**CITY OF PORTLAND, MAINE
DEVELOPMENT REVIEW APPLICATION
PLANNING DEPARTMENT PROCESSING FORM
Planning Copy**

Unifirst Expansion
Project Name/Description

430 - 430 Riverside Ind Pkwy, Portland, Maine
Address of Proposed Site
354 B002001
Assessor's Reference: Chart-Block-Lot

Re: Unifirst Expansion – Final Plans
Application # 2006-0151

Drawing No.
C100

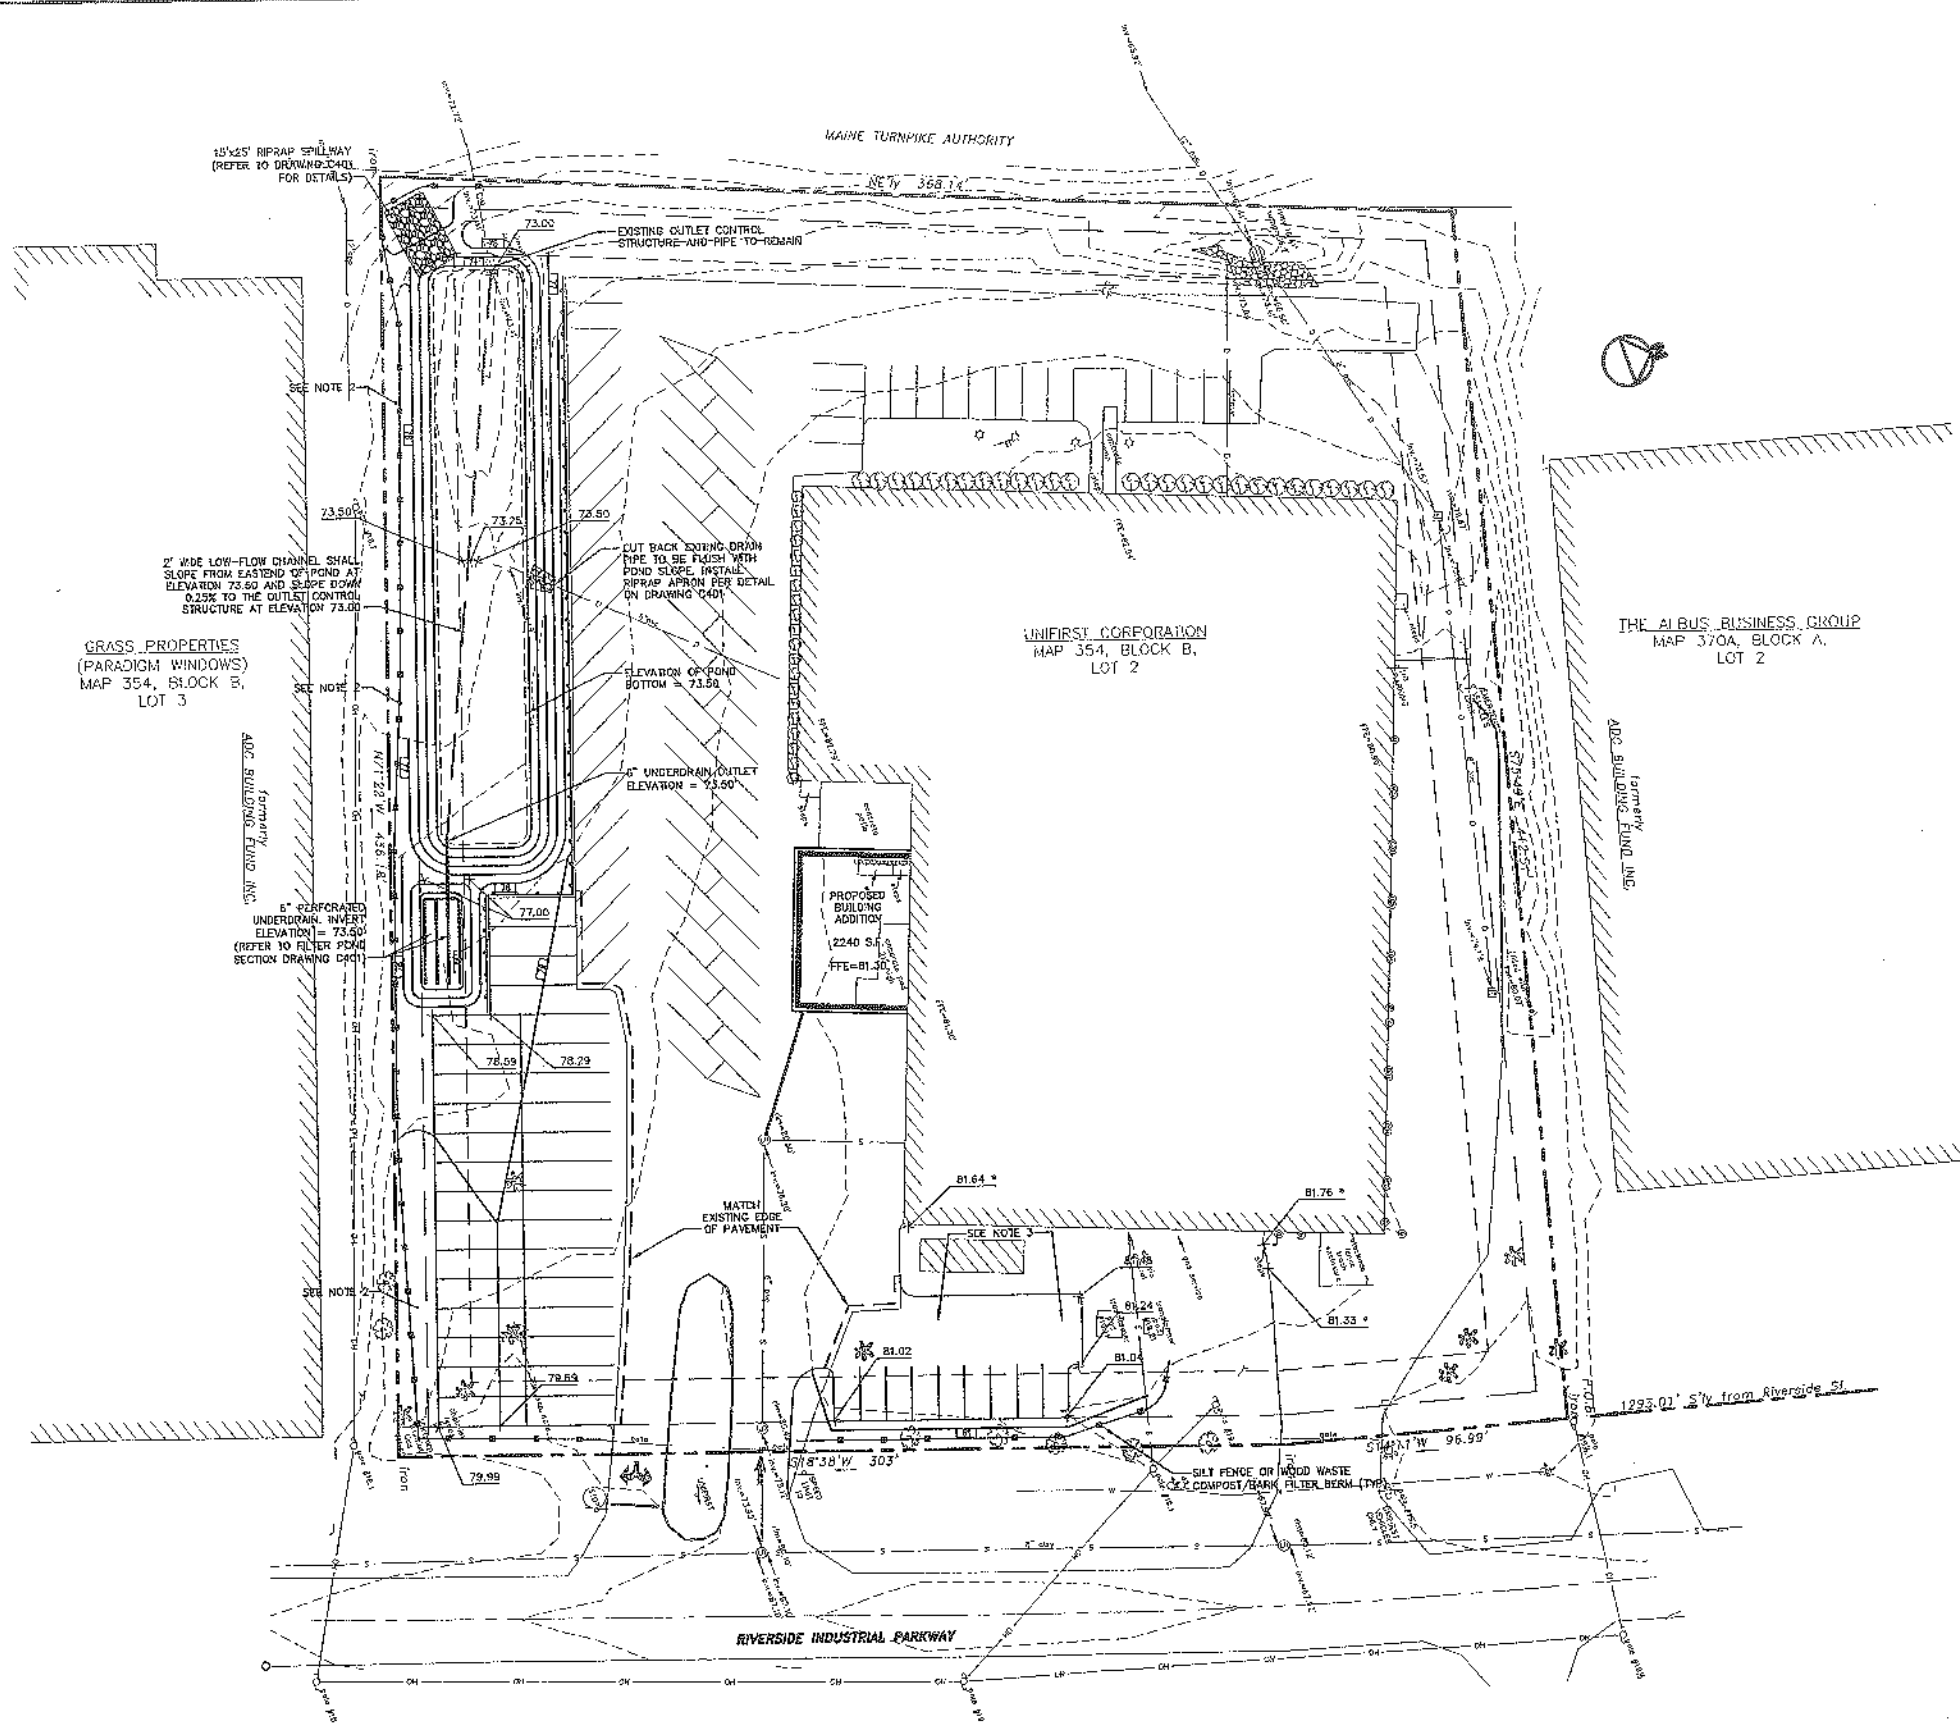
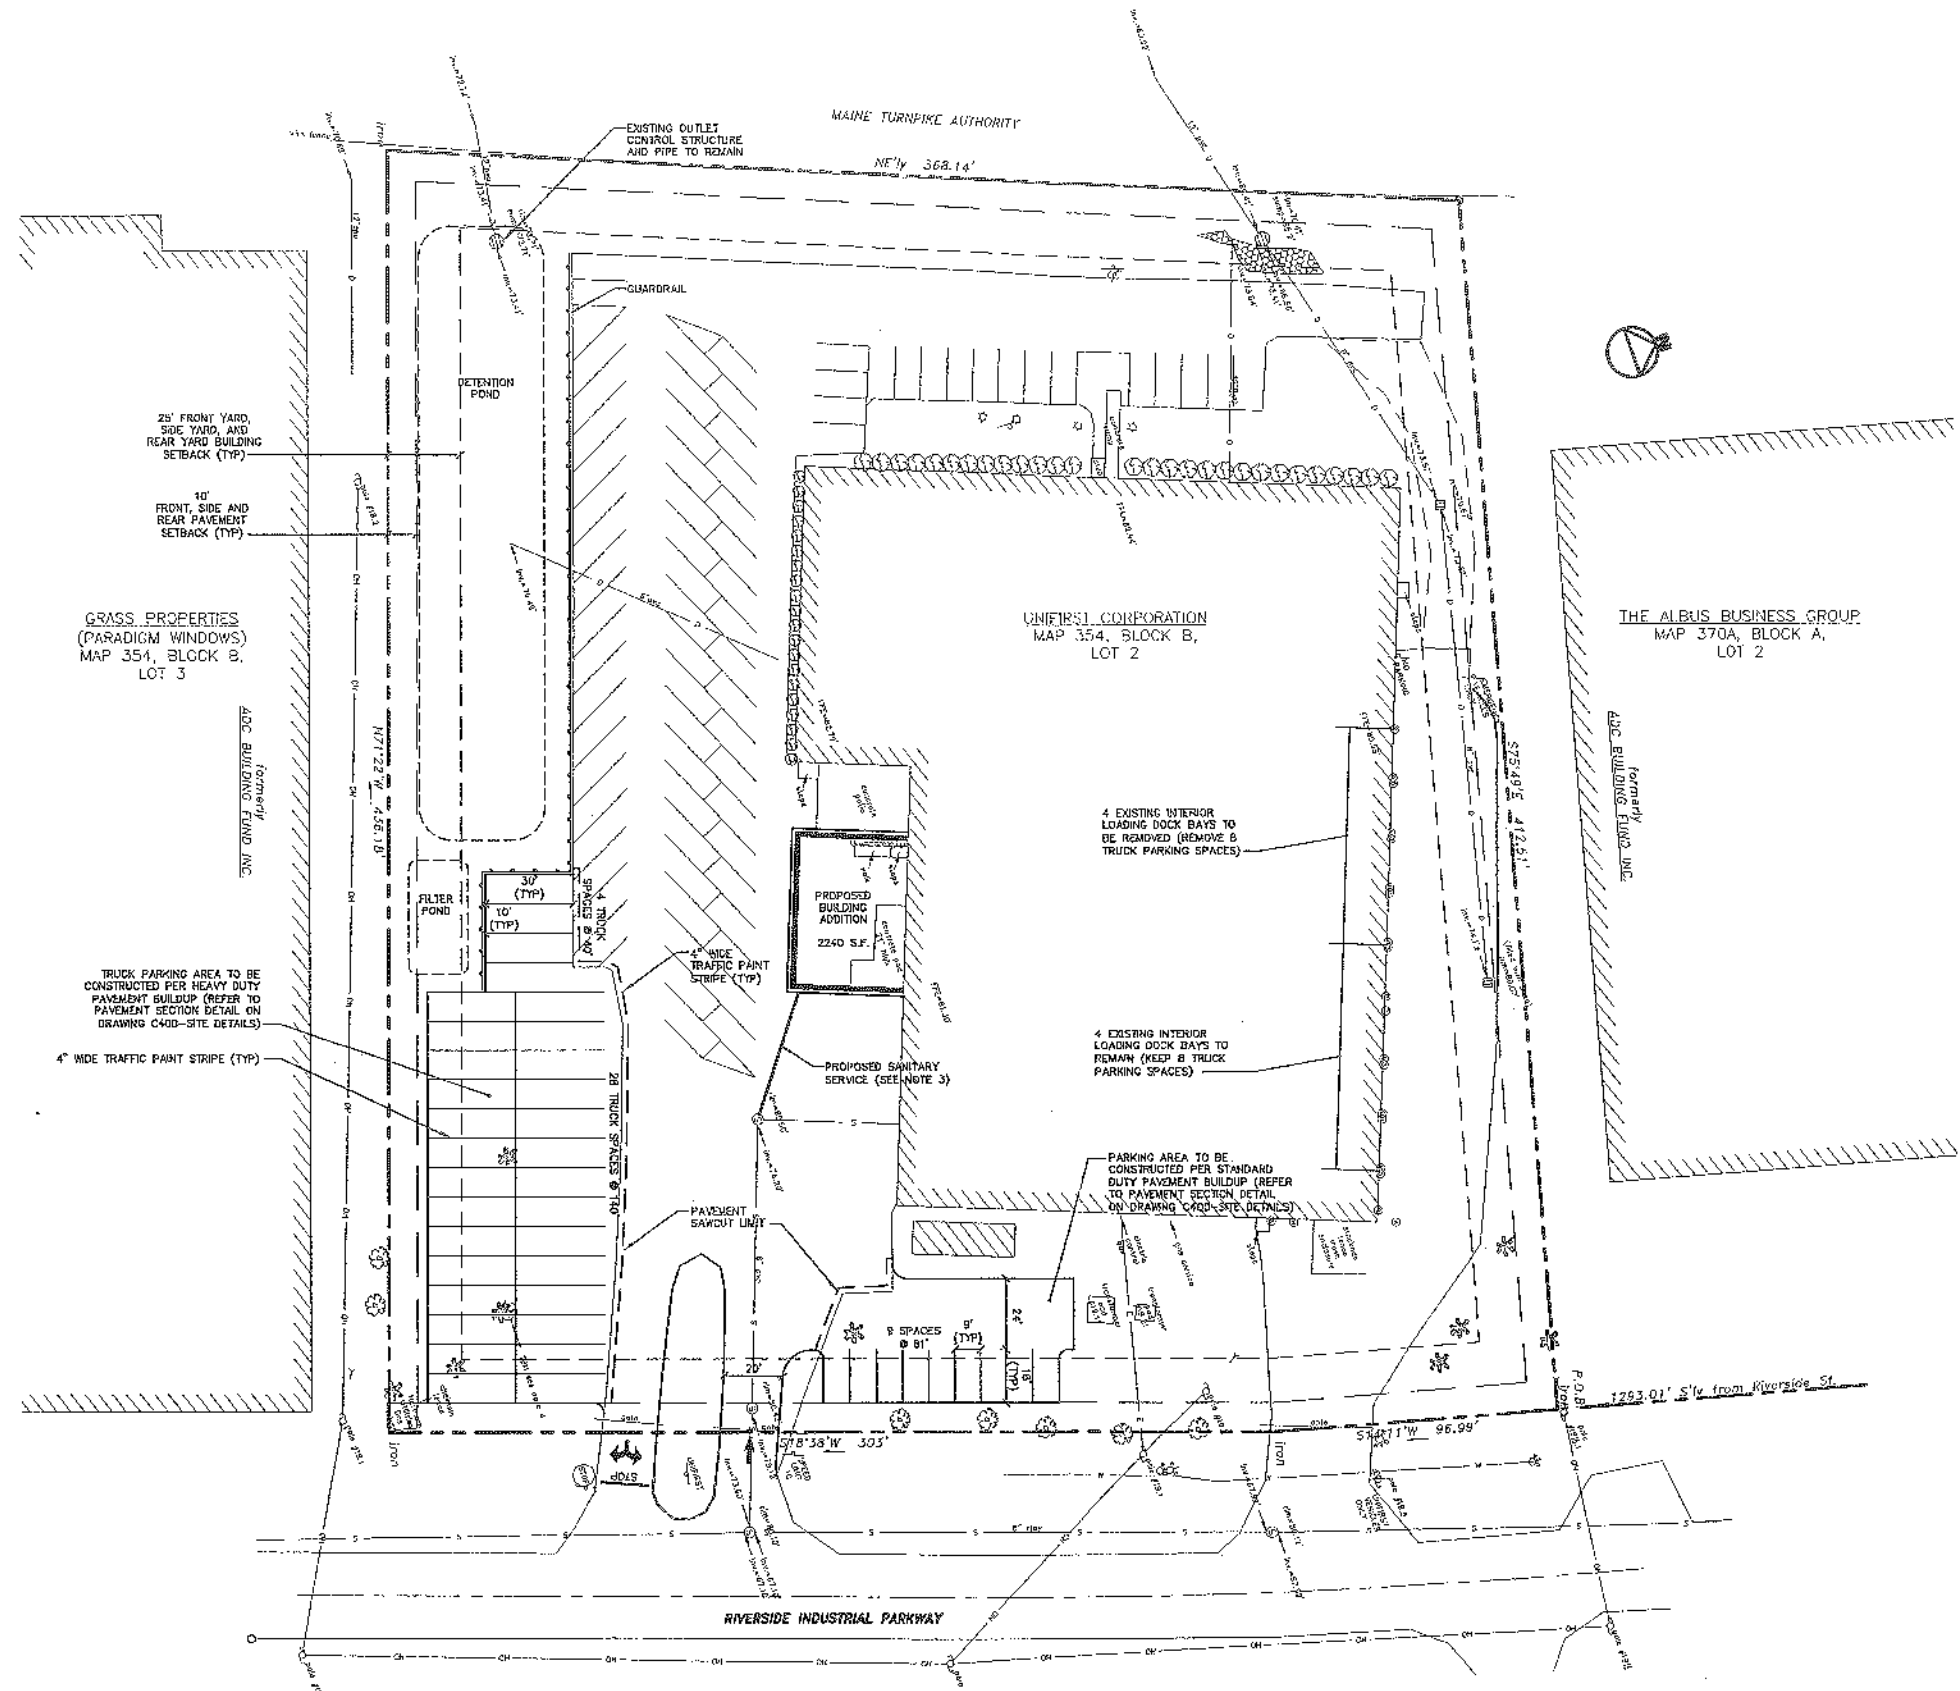
Just touching base on a few things for UniFirst. Drawing C100 indicates a 10' high stockade fence at the dumpster pad. Would there be a problem changing this to an 8' high fence? Fence contractors seem to stock 8' in lieu of 10'.

Let me know on the dumpster fence height and if you have an update on the recent design changes to the site perimeter fence. I still need to provide pricing to the owner on this.

Response: We have added a 10 foot high vinyl fence around the trash compactor and attached a catalog cut for the proposed vinyl fence. Note that the catalog cut only shows an 8 foot high fence. The applicant is proposing to install the fence on longer poles and provide a vinyl skirting material around the base to provide the 10 foot height. The posts will be reinforced with steel poles for additional strength. Specific notes regarding the trees to remain have been added to the Landscape Plan as requested. We have included 7 sets of revised plans and a compact disk with digital files of the plans as requested.
